TMI_870-WL(2)-01

Unique Identifier	Agency IR #	Annex	Agency / Group / Stakeholder	Cross Reference / Comment / Information Request / Response	
TMI_870-WL(2)-01	WL(2)-01	1	CEA Agency	Reference to EIS Guidelines:	Part 2, Section 9.1.2
				Reference to EIS / Appendix	Sections 5.9.2.1 - 5.9.2.4, Table 5.9.1; Appendix G; Section 9.1.2, Table 9.5, Figures 9.4 - 9.7; Appendix R Executive Summary, Section 2.2
				Cross-reference to Round 1 IRs	TMI_145-WL(1)-02, TMI_147-WL(1)-04, TMI_162-WL(1)-19, TMI_542-AC(1)-216
				<p>Context and Rationale:</p> <p>Ecosites</p> <ul style="list-style-type: none"> • The Agency requested a figure and summary table depicting the Project footprint components and ecosites. • However, the following issues were identified: <ul style="list-style-type: none"> ○ Figure 2a and 2b in TMI_145-WL(1)-02 includes white polygons which are not defined in the legend and appear to be used for both disturbed areas as well as undisturbed areas adjacent to Lola Lake. ○ Table 3 in TMI_145-WL(1)-02 does not include all wetland types identified in Appendix S. For example, WLD4, described as a wetland complex including swamp and marsh areas (Appendix S_Figure Vegetation Communities

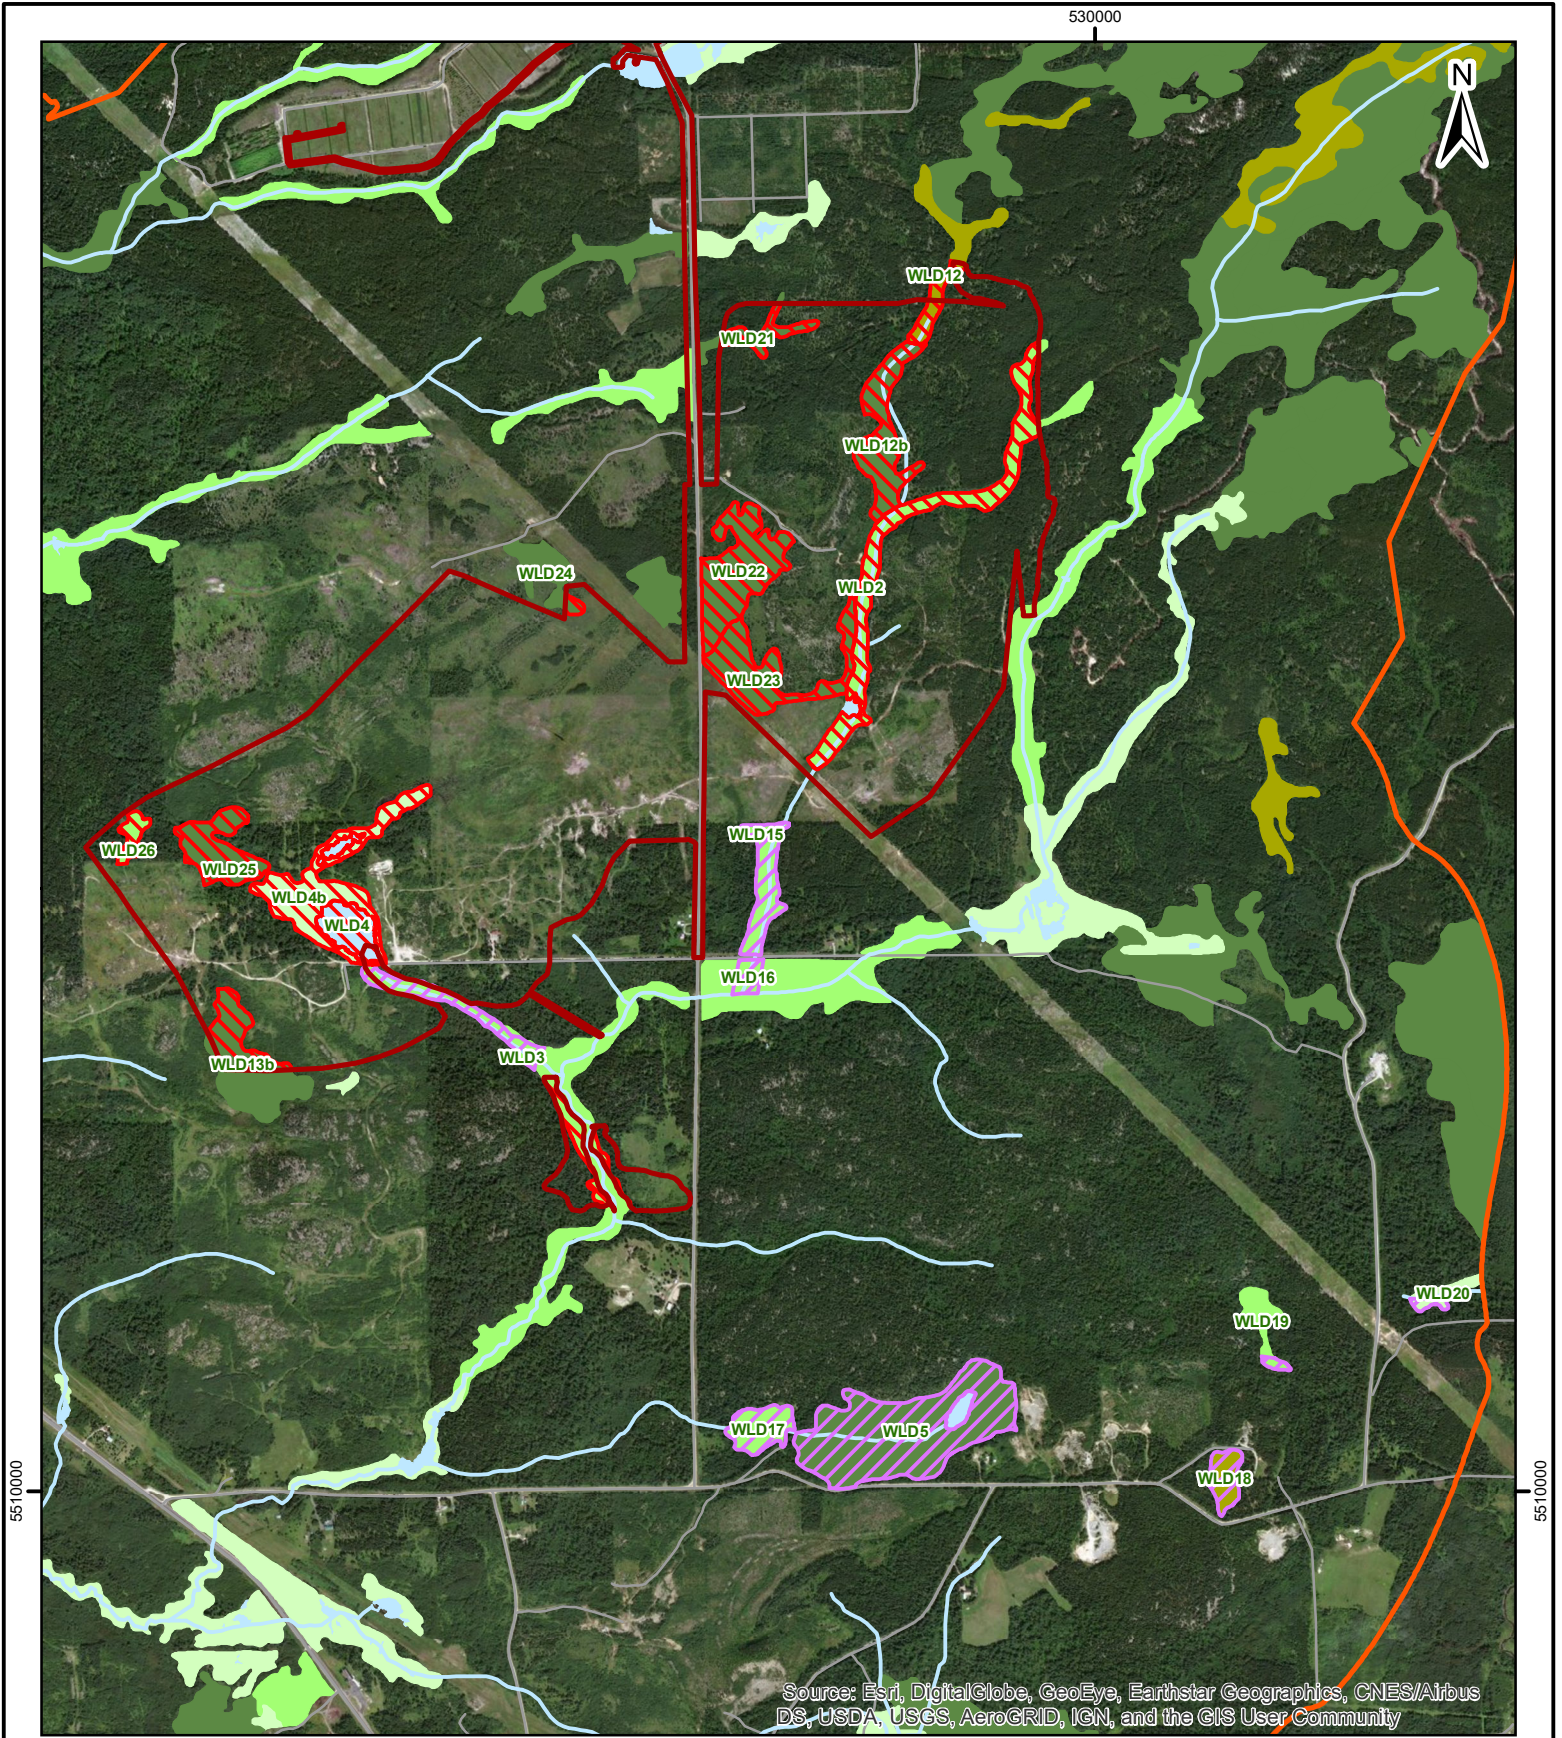
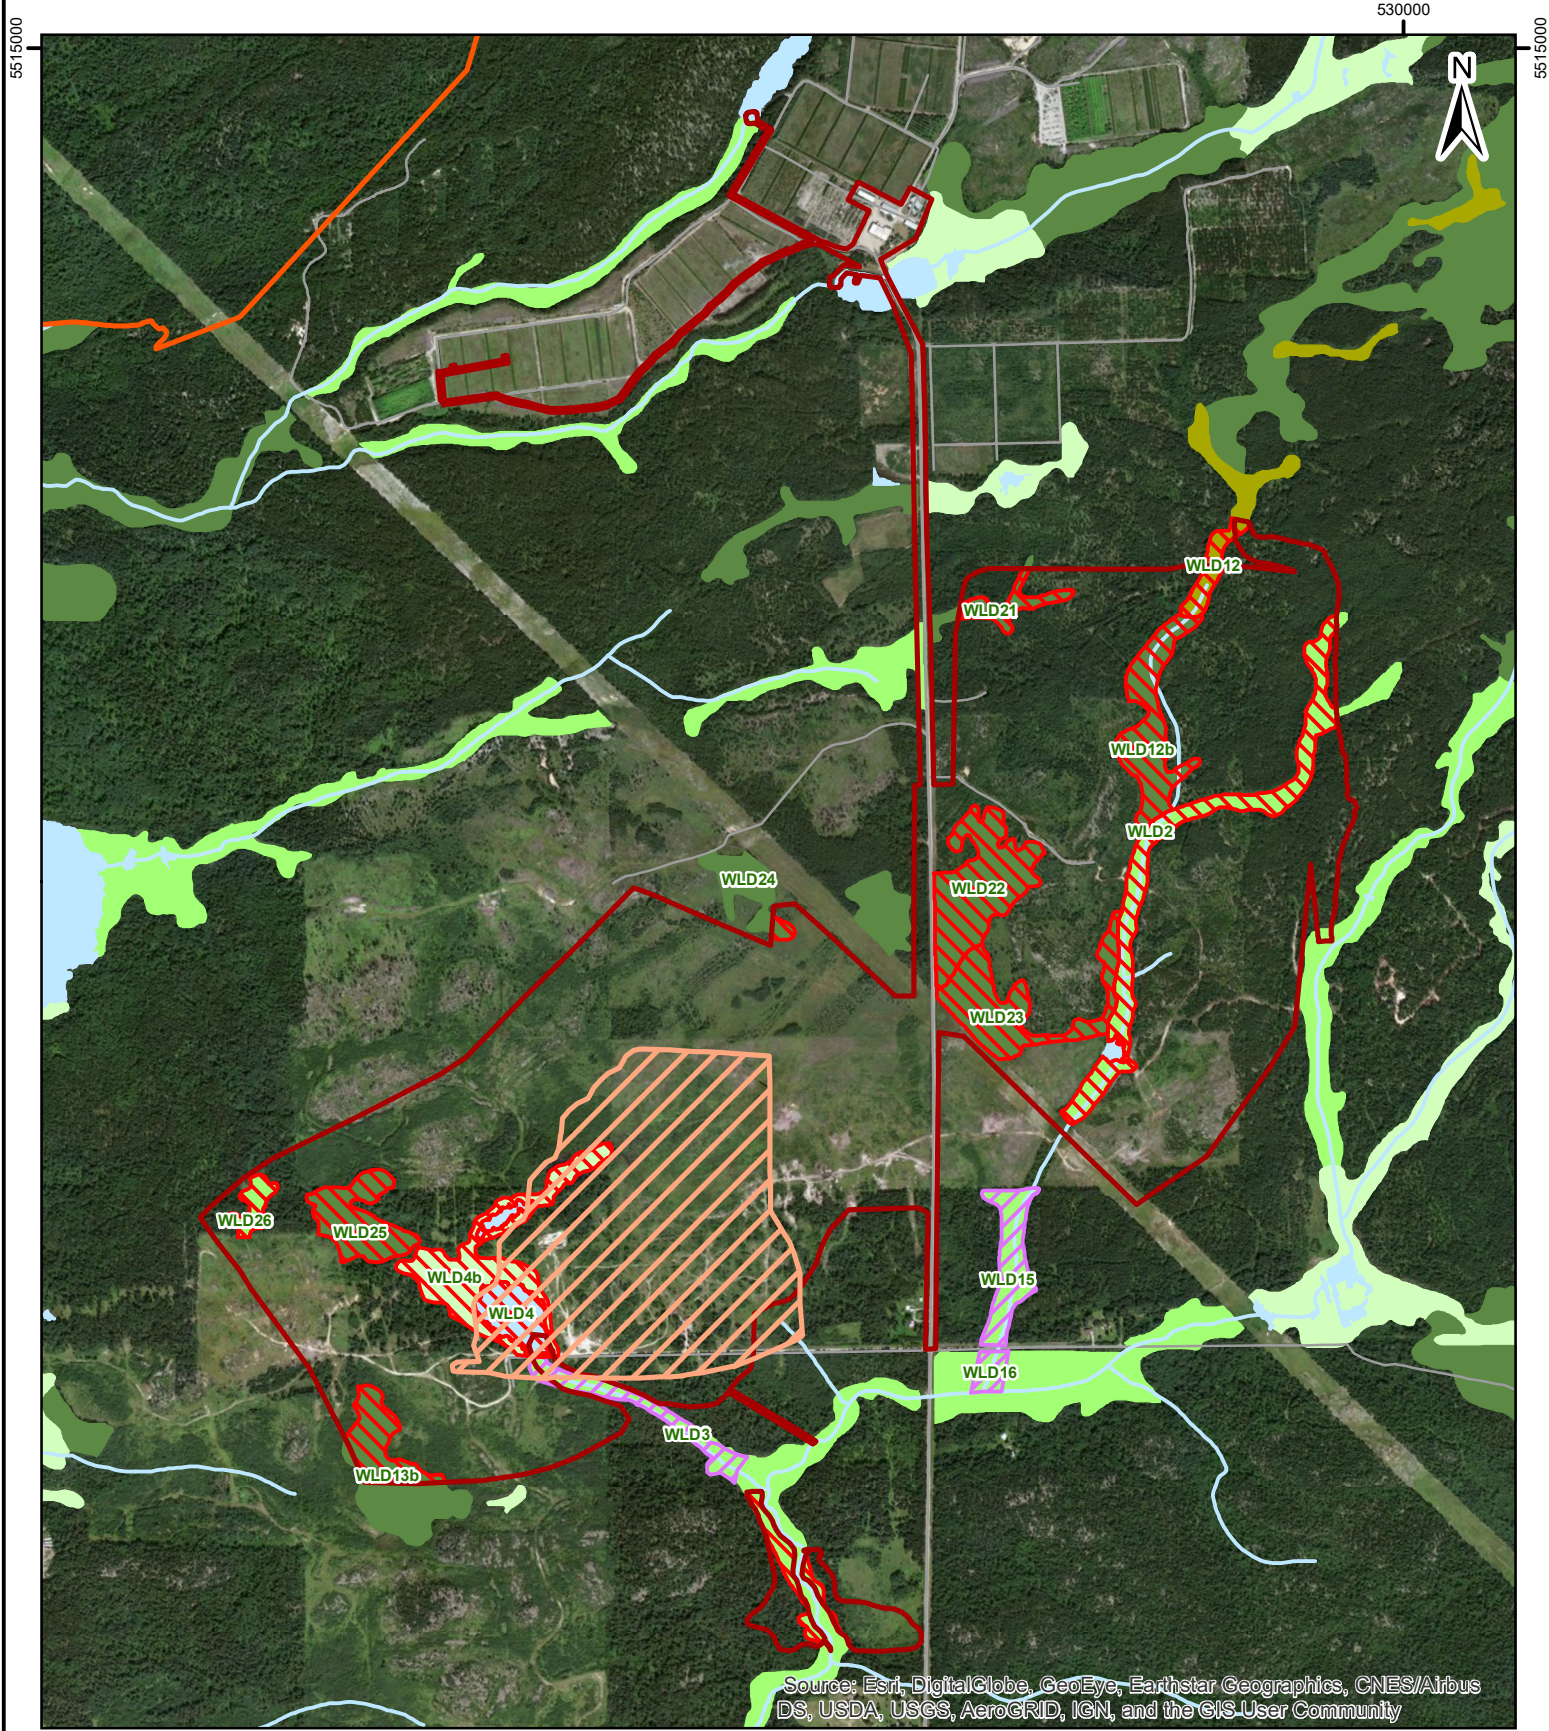
Unique Identifier	Agency IR #	Annex	Agency / Group / Stakeholder	Cross Reference / Comment / Information Request / Response
				<p><u>Part F.</u> Although the habitat categories have been updated (see TMI_870-WL(2)-01) and additional wetlands have been surveyed (see response to part C), the conclusions of the effects assessment presented in the revised EIS remain unchanged. All wetland ecosites were accounted for in the initial effects assessment.</p> <p><u>Part G.</u> The proposed mitigation methods and monitoring programs are based on the conclusions of the effects assessment presented in the revised EIS and remain unchanged with the update of the habitat categories.</p> <p><u>Agency Comment on Draft Response:</u></p> <p>A. The Agency has reviewed the response to WL(2)-02A including TMI_871-WL(2)-02_Figure_1 and has four comments:</p> <p>A1. See discussion regarding “Project Study Area” in WL(2)-01A1.</p> <p>A2. As discussed in TMI_870-WL(2)-01(A1), the Agency has reviewed TMI_871-WL(2)-02_Figure_1. The Agency requests confirmation that the Groundwater ZOI has been updated based on updated groundwater modelling (if applicable) and wetland mapping. The Agency requests the proponent include the full extent of the Groundwater ZOI within the LSA, given this will include the potential extent of indirect Project effects on the adjacent terrestrial environment.</p> <p>A3. The Agency requests confirmation that the Forest Resource Inventory wetland mapping was updated based on field survey data. See discussion in WL(2)-01(A2).</p> <p>A4. TMI_871-WL(2)-02_Figure_1 is missing wetland connection between WLD3 and WLD4. Update TMI_871-WL(2)-02_Figure_1 to include all Project components within the “Project Study Area” [as discussed in TMI_870-WL(2)-01(A1)]. Confirm the Groundwater ZOI has been updated based on updated groundwater modelling and wetland mapping. Update the terrestrial LSA to include the Groundwater ZOI [as discussed in TMI_870-WL(2)-01(A1)]. Confirm wetland classifications were updated based on field survey data as necessary [as discussed in TMI_870-WL(2)-01(A2)]. Ensure TMI_871-WL(2)-02_Figure_1 includes all wetlands within the LSA.</p> <p>C. The Agency has reviewed TMI_871-WL(2)-02_Figure_2, TMI_871-WL(2)-02_Table_1 and TMI_871-WL(2)-02_Table_2. Update TMI_871-WL(2)-02_Figure_2 to include all Project components within the “Project Study Area” [as discussed in TMI_870-WL(2)-01(A1)] and the updated LSA [as discussed in TMI_870-WL(2)-01(A1)]</p> <p>D. The Agency has reviewed TMI_871-WL(2)-02_Figure 2a and TMI_871-WL(2)-02_Figure 2b and have three comments.</p>

Unique Identifier	Agency IR #	Annex	Agency / Group / Stakeholder	Cross Reference / Comment / Information Request / Response
				<p>D1. Several wetlands displayed in TMI_871-WL(2)-02_Figure 2a and TMI_871-WL(2)-02_Figure 2b are not shaded according to the wetland categories displayed in the legend. It appears that they have been shaded using the "surveyed wetland" shading from TMI_871-WL(1)-02_Figure_2.</p> <p>D2. Wetland WLD13a is not shown on the figure.</p> <p>D3. The figures present the "impacted" wetlands within the LSA. These appear to be predominantly restricted to direct impacts associated with vegetation removal. The Agency requests the proponent consider direct and indirect effects of the Project on wetlands within the PSA and LSA, as described in the context and rationale for TMI_871_WL(2)-02. Specifically, "an assessment of effects to wetland habitat from alterations to surface water and indirect effects associated with alterations to groundwater hydrology (such as reduced surface water input) has not been provided. These alterations include:</p> <ul style="list-style-type: none"> • the proposed diversion channel; • the loss of WLD5; • the headwater of Black Water Creek Tributary; • Thunder Lake and Wabigoon Lake water levels; • Thunder Lake Tributary 2 and Tributary 3 flow; and • Hoffstrom's Bay Tributary flow." <p>The FUP addendum states "the upstream portion of Blackwater Creek Tributary 1 will be enclosed within the operations area and, [...], will drained [...] during either the site preparation and construction, or the operations phases of the Project. [...]. Further, the removal of the upstream portion of Blackwater Creek Tributary 1 and associated drainage area, means that the portion of Blackwater Creek Tributary 1 that is immediately downstream from the operations area is expected to be dry and, therefore, it is not expected to contain fish."</p> <p>The Agency requests the proponent review and provide rationale for including or not including the following wetlands as "impacted" in TMI_871-WL(2)- 02_Figure 2a and TMI_871-WL(2)-02_Figure 2b:</p> <ul style="list-style-type: none"> • a coniferous swamp in the northwest corner of the operations area: occurs within the Operations Area and Project Footprint. • the wetland connecting WLD3 and WLD4: the majority of the catchment area will be removed; the hydrology of the wetland will be disrupted by the removal of WLD4 and WLD4b; a portion of the wetland occurs within the Operations Area. • the entirety of WLD5: a portion of WLD5 has not been included in the "impacted" boundary. • fen north of WLD12: located within Groundwater ZOI and north of diversion channel. • an open water component at the southern end of WLD2: occurs within the Operations Area and Project Footprint.

Unique Identifier	Agency IR #	Annex	Agency / Group / Stakeholder	Cross Reference / Comment / Information Request / Response								
				<p>C. TMI_871-WL(2)-02_Figure_2a and TMI_871-WL(2)-02_Figure_2b, along with the associated tables have been updated to include all the Project components within the PSA. All of the areas within the PSA are assumed to be impacted, which includes those areas identified as “interstitial areas”. These “interstitial areas” correspond with roadways, pipelines, and constructed features such as impoundment dams, ditches and berms.</p> <p>D) The wetland assessment, figures and tables were updated to reflect the new LSA (including the ZOI) and the PSA (see response to TMI_870-WL(2)-01).</p> <p>D1. The wetland categories in the legends of TMI_871-WL(2)-02_Figure_2a and TMI_871-WL(2)-02_Figure_2b have been updated with the appropriate categories shown in the figures.</p> <p>D2. WLD13a has been added to TMI_871-WL(2)-02_Figure_2b.</p> <p>D3. The direct and indirect effects to wetlands are included on TMI_871-WL(2)-02_Figure_2a and TMI_871-WL(2)-02_Figure_2b. A rationale for the inclusion or exclusion of the specific effects identified by the reviewer is provided below in Table 1.</p>

Unique Identifier	Agency IR #	Annex	Agency / Group / Stakeholder	Cross Reference / Comment / Information Request / Response
				<p>TMI_871-WL(2)-02_Figure_2a and TMI_871-WL(2)-02_Figure_2b now show all of the Project components as defined by the PSA and the appropriate shading has been used within the figure and legend. The effects to wetlands shown in the figures has also been categorized by direct and indirect effects.</p> <p>E) The vegetation area and impact summary tables have been updated as requested using the newly defined PSA, the updated LSA to include the ZOI, and the impacted wetlands from indirect Project effects.</p> <p>F) The wetland effects assessment has been updated to reflect the expanded LSA, as requested. The groundwater model was updated as part of the responses to the Round 2 information requests; however, the update did not result in a change to the ZOI and therefore does not change the wetlands effects assessment. A revised effects assessment, including a revised determination of significance, has been provided in TMI_871-WL(2)-02_Table_4, TMI_871-WL(2)-02_Table_5 and TMI_871-WL(2)-02_Table_6. For clarity, Treasury Metals has assessed the VCs presented in the revised EIS (April 2018) using the same template provided by the Agency. Although the PSA and LSA have changed, the conclusions of the updated effects assessment are similar to those presented in the revised EIS.</p> <p>It is important to note that 24.16 ha of marsh habitat loss as a result of the Project will be offset by the construction of the fish compensation / offsetting ponds, the formation of the pit lake in the post-closure phase and the creation of marsh habitat in Collection Ponds 2a and 2b on either side of Blackwater Creek Tributary 1 This wetland offsetting habitat is shown in TMI_871-WL(2)-02_Table_4.</p> <p>G) The Agency is directed to the response to TMI_873-WL(2)-04 for details on the wetland follow-up program.</p> <p><u>FINAL RESPONSE</u></p> <p><u>Part A.</u> The wetland mapping has been updated for the Project Study Area (PSA) and the Local Study Area (LSA; which now includes the full groundwater ZOI), as illustrated in TMI_871-WL(2)-02_Figure_1. Rather than relying on satellite imagery and Land Information Ontario (LIO) groundcover data (as used in the initial assessment), the updated mapping relied primarily on the updated Forest Resource Inventory (FRI) groundcover habitat classifications to identify wetland areas (please refer to TMI_870-WL(2)-01). This data set is the most extensive and comprehensive available to Treasury Metals. In June of 2018, additional wetland surveys were completed within the LSA. During this time, some ecosites were ground-truthed using the FRI groundcover habitat classifications, and all field observations confirmed the existing FRI classifications. As such, it is the professional opinion of Treasury Metals' independent consultants that the comprehensive dataset is representative of the actual conditions in the field.</p> <p><u>Part B.</u> The Agency previously identified four wetlands (or portions of wetlands) they wished incorporated into the wetland survey and mapping. These wetlands (WLD12, WLD13a, WLD13b and WLD14) were surveyed in June of 2018 and are shown in TMI_871-WL(2)-02_Figure_2.</p>
